# ◀ HEALTH & SAFETY ALERT ▶

## TC125 – E-Tunnelling Machine

**FIG32**

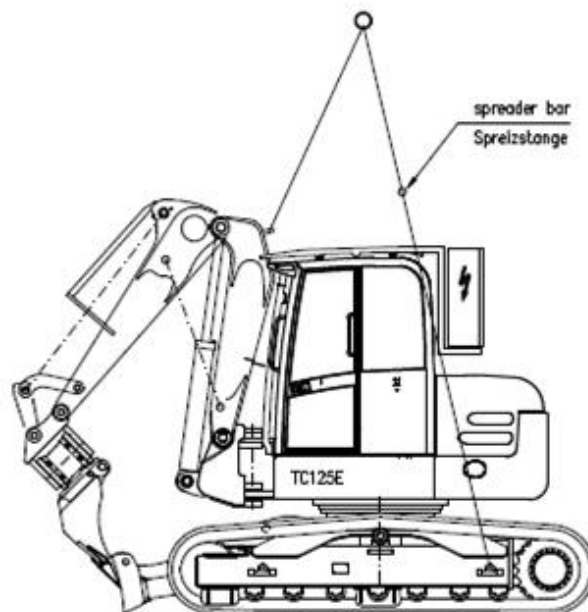
The wording within bullet point 3 of section 7.2 states: “Turn the upper carriage so that the working direction is opposite to the dozer blade in the “straightaway” position.

The above statement is incorrect and those planning lifting operations for this machine should refer to FIG.32 (page 59 within the manual) which depicts the upper carriage in the correct position with the working direction over the dozer blade (shown below).

Please warn your teams of the error in the manual until TEREX communicate their amendment.
